**Safety Evaluation Report
License Amendment for the Jane Dough Unit at the
Nichols Ranch In Situ Recovery Project
in Johnson and Campbell Counties, Wyoming, Revision 1**

Materials License No. SUA-1597

Docket No. 040-09067

URANERZ ENERGY CORPORATION

Figure 1. Stratigraphic Column in Jane Dough Unit
(adopted from Figure JD-D5-2, "Stratigraphic Column," of Uranerz 2014f)

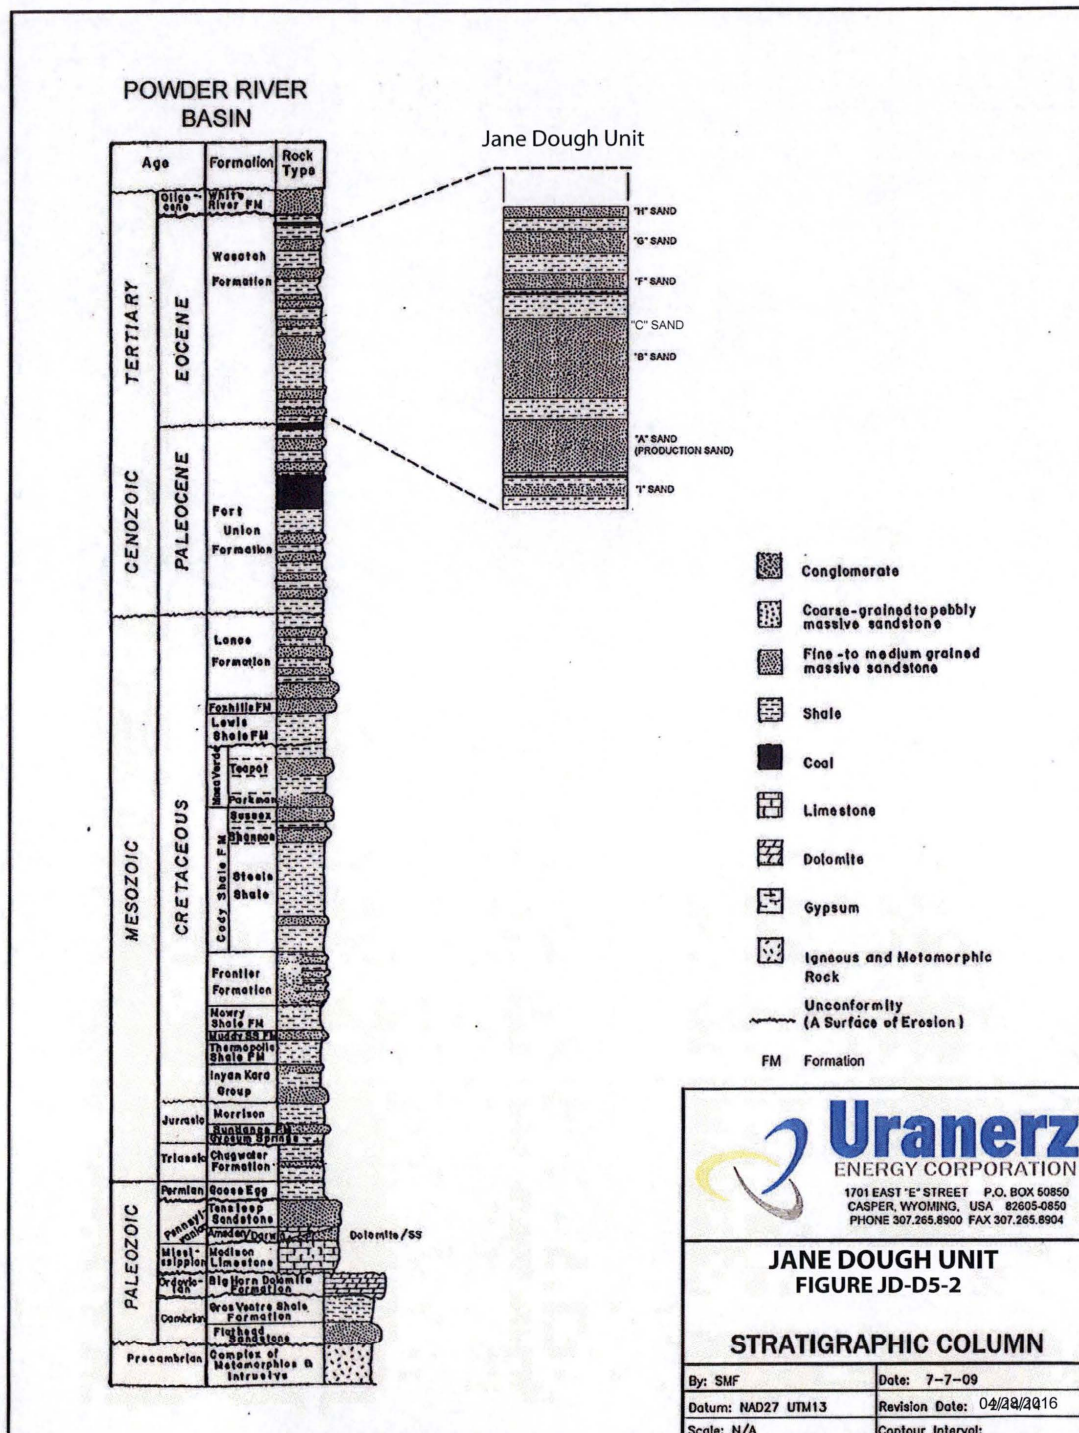
The licensee identified eight fluvial sandstone horizons. The licensee referred to these horizons from shallowest to deepest as, the H, G, F, C, B, A and 1 Sands (see SER Figure 1) and further indicated that the notable sand units (i.e. the thicker and more aerially extensive units) are the G, F, B, A and 1 Sands. The licensee indicated that the Jane Dough Unit sands are stratigraphically the same as those at the currently licensed Nichols Ranch Unit.

The Jane Dough Unit is located in the south-central Powder River Basin, to the southwest of the Middle Pumpkin Butte. The general stratigraphy of the area is shown in SER Figure 1. The regional geologic structure is relatively flat with a gentle dip to the southwest toward the basin axis. The uppermost regional aquifers are found in the Wasatch Formation, which is also the host formation for the uranium deposits. Groundwater in the Wasatch aquifers generally flows to the north and northwest. Underlying the Wasatch are aquifers in the sandstones and coal seams of the Fort Union Formation, and flow in these aquifers is also expected to be generally to the north and northwest. Underlying the Fort Union is the Lance Formation, which is composed of very fine to fine-grained sandstone, shale, and coal beds. Ground water flow direction in the Lance Formation is expected to be to the north. The Fox Hills sandstone is located below the Lance and is composed of fine- to medium-grained sandstone.

Figure 2. Potentiometric Surface of the Jane Dough Unit A Sand Aquifer in 2013 (elevation in feet, modified from Jane Dough Technical Report Figure JD-D6-5)

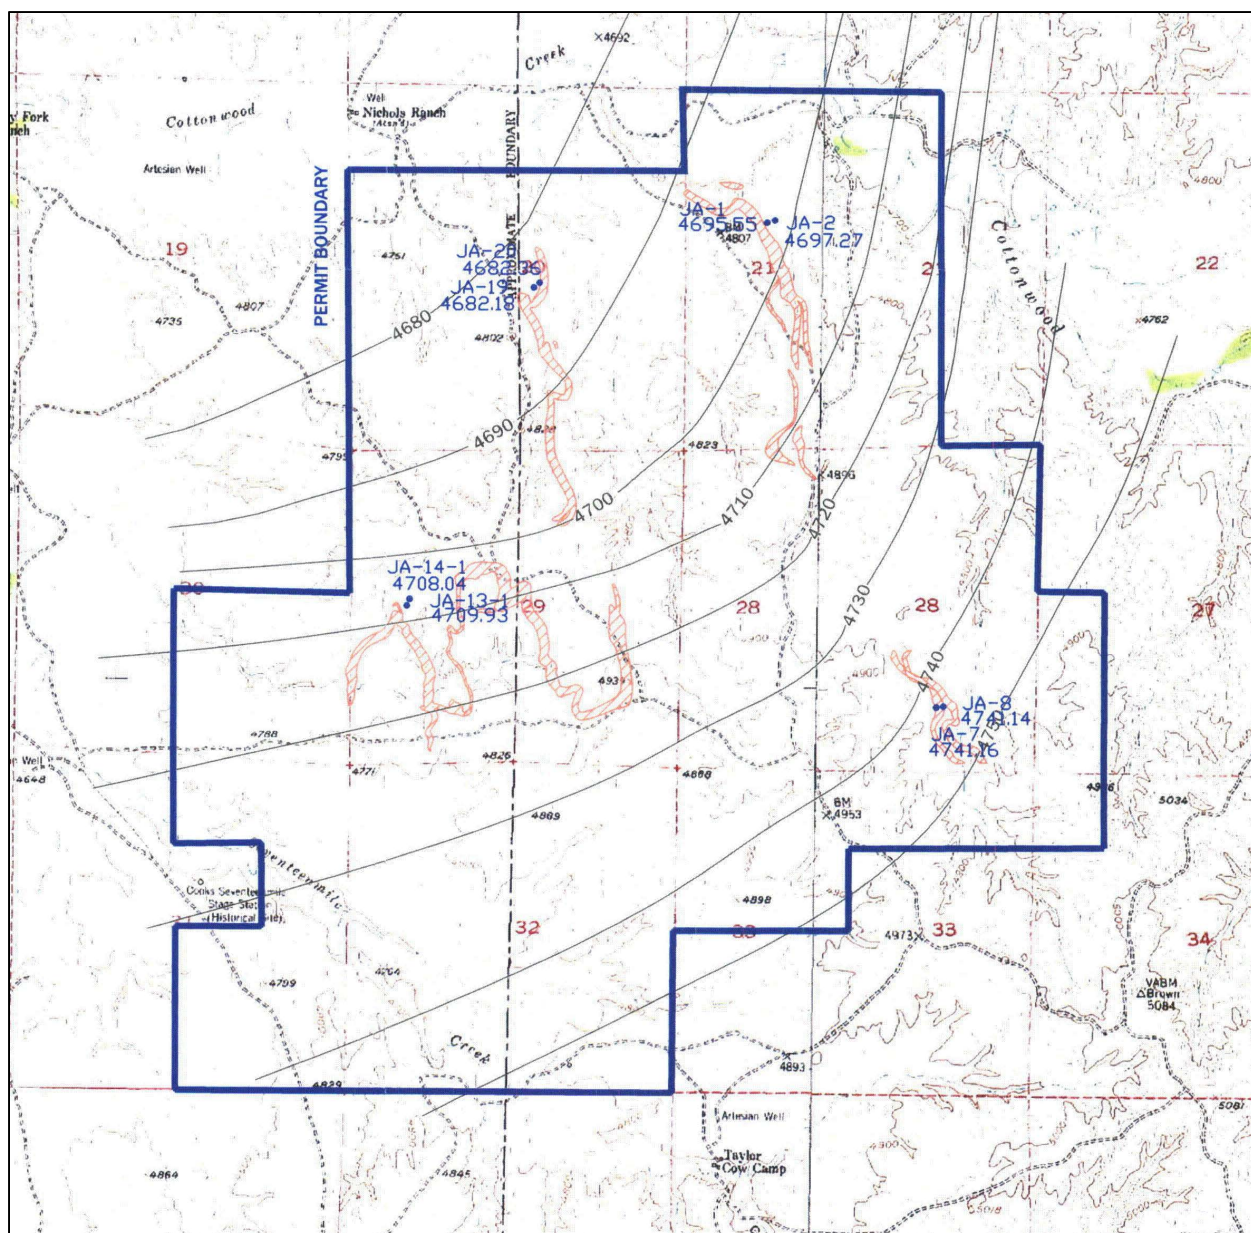
The A Sand is the ore production zone and is continuous over the majority of the Jane Dough Unit with thicknesses ranging from 15.2 to 30.5 m (50 -110 ft). The licensee used 8 wells, as shown in SER Figure 2, to measure water levels in the A Sand. Water level measurement in the A Sand demonstrate that the aquifer is confined, with a potentiometric surface rising approximately 61 – 91.4 m (200 - 300 ft) above the top of the sand unit.

Based on the potentiometric contours, the licensee reported the groundwater flow direction is to the northwest with a gradient of 0.0064 m/m (0.0064 ft/ft). Using this gradient, an effective

porosity of 0.05 and an average hydraulic conductivity of 0.08 m/day (0.25 ft/day), the licensee calculated an average A Sand groundwater flow velocity of 3.7 m/yr (12 ft/yr).

Figure 3. Jane Dough Unit Stock Wells and Domestic Wells

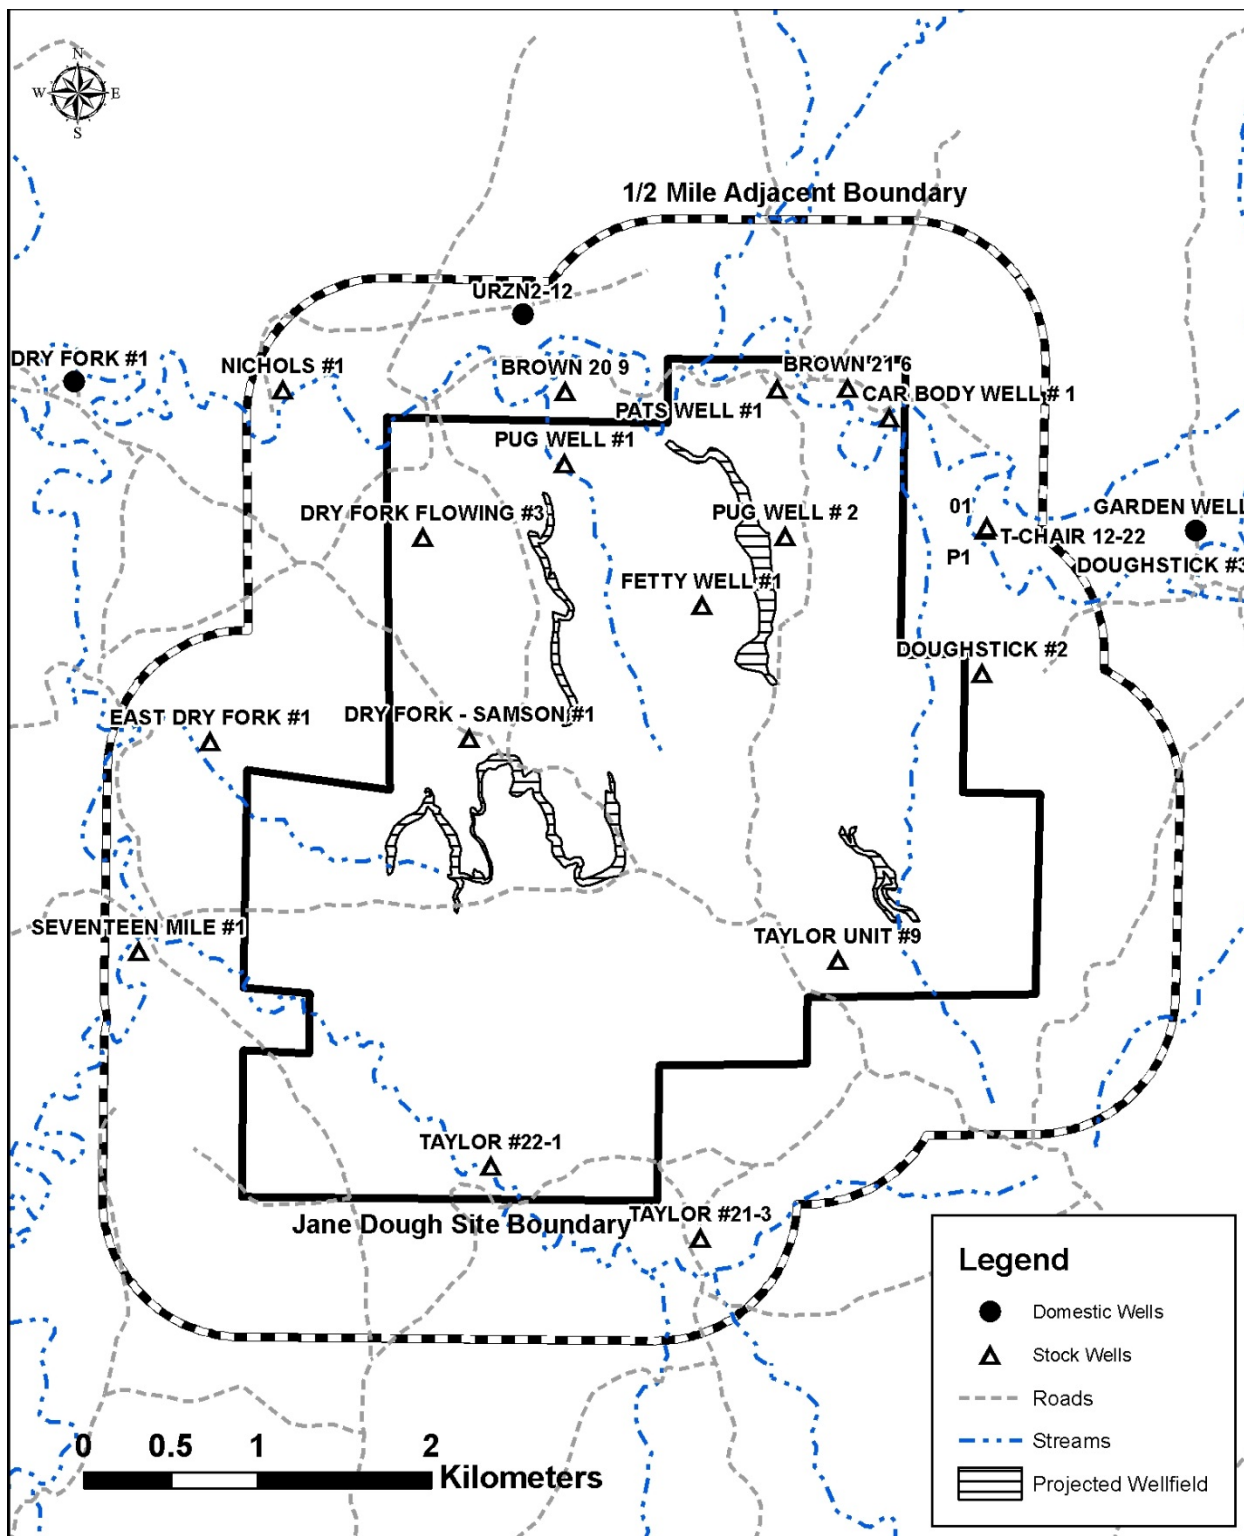
SER Figure 3 presents the locations of stock wells and domestic wells located within 0.8 km (0.5 mi) and 5 km (3 mi), respectively, of the Jane Dough Unit. Note that wells P1, 01 and T-CHAIR 12-22 are in close proximity and appear as a single symbol on SER Figure 3. Similarly, wells Doughstick #3 and Garden Well appear as a single symbol on SER Figure 3.

Based on NRC staff review of the Wyoming e-permit database, the average appropriation for the wells presented in SER Figure 3 is less than 38 Lpm (10 gpm).

Figure 4. Jane Dough Unit preoperational Radon-222 concentrations in air

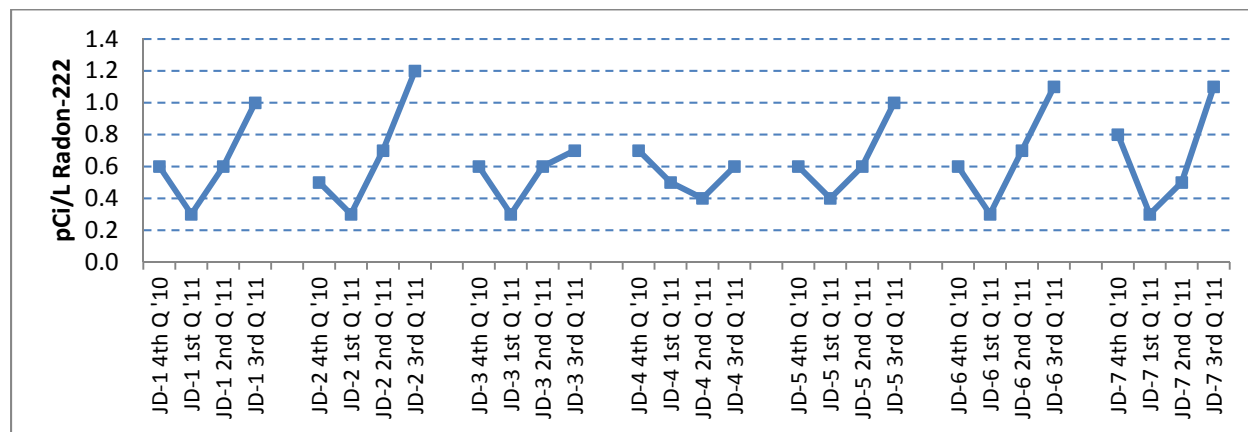
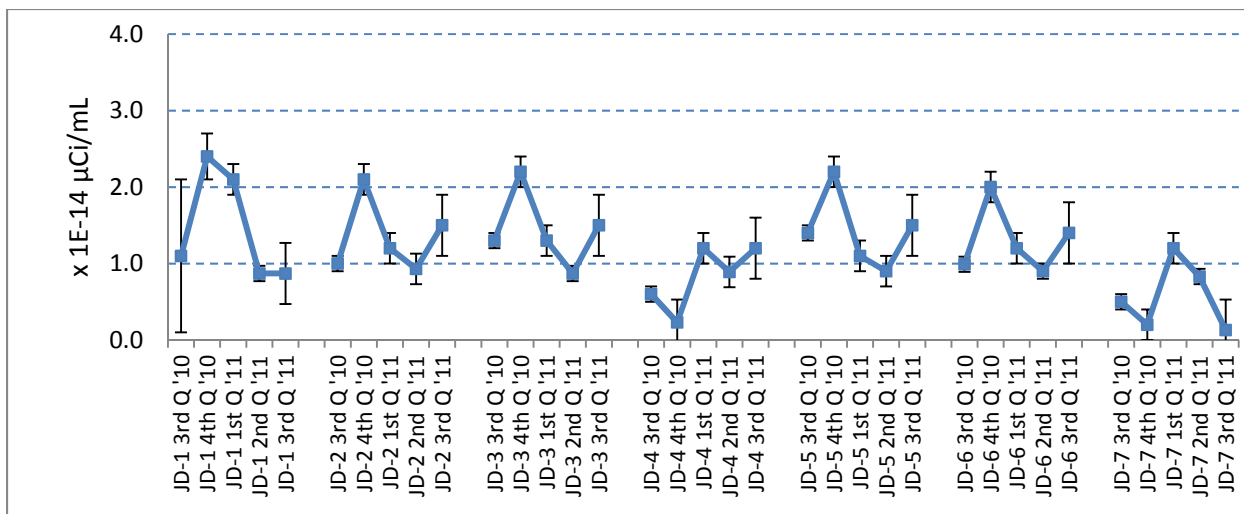
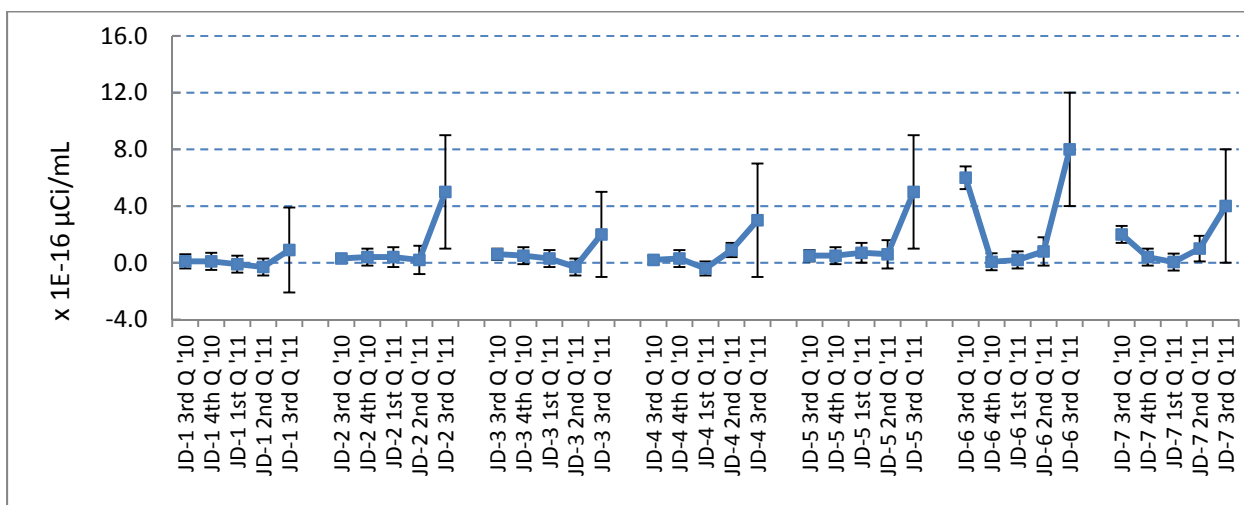
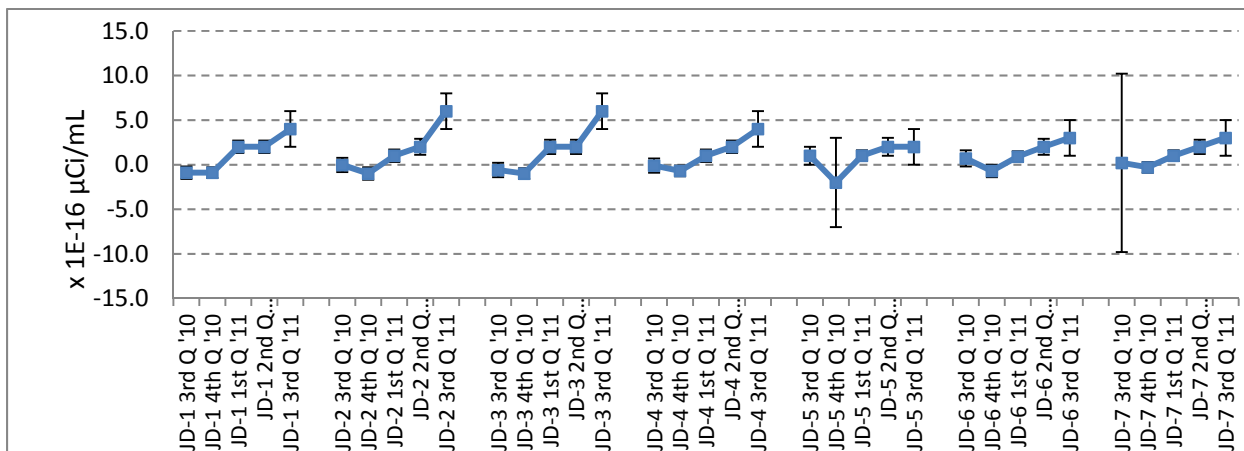
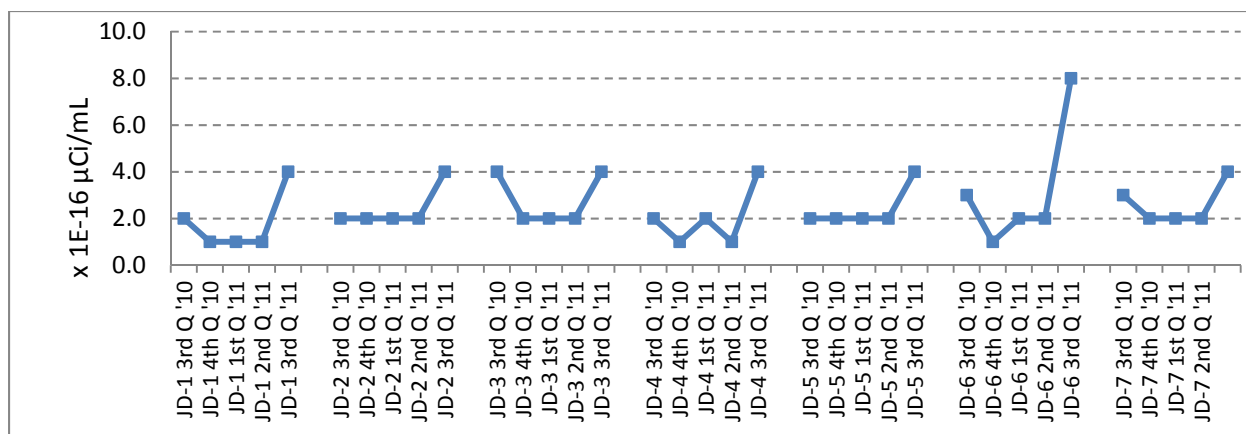
The NRC staff evaluated the pre-operational sample results by plotting the results on charts and examining the data for unusual or unexpected temporal or spatial trends. These trend charts are presented in SER Figures 4 through 8 below. Radon-222 concentrations show no discernable spatial trend and vary from lows around 0.3 pCi/L in the winter (1st Q 2011) to highs around 0.6 pCi/L to 1.2 pCi/L in the fall (3rd Q 2011). This is normal, because frozen soil and snow attenuates radon-222 emanation in the winter and low precipitation, dry soil, and elevated temperatures in the summer and early fall cause radon-222 diffusion and emanation rates to increase. As expected, lead-210, a long-lived progeny of radon-222, is detectable at low and variable concentrations consistent with changes in regional radon-222 concentrations. Radium-226, thorium-230 and uranium are generally associated with mill tailings, which are not present either at the Nichols Ranch ISR Project or any nearby facility.
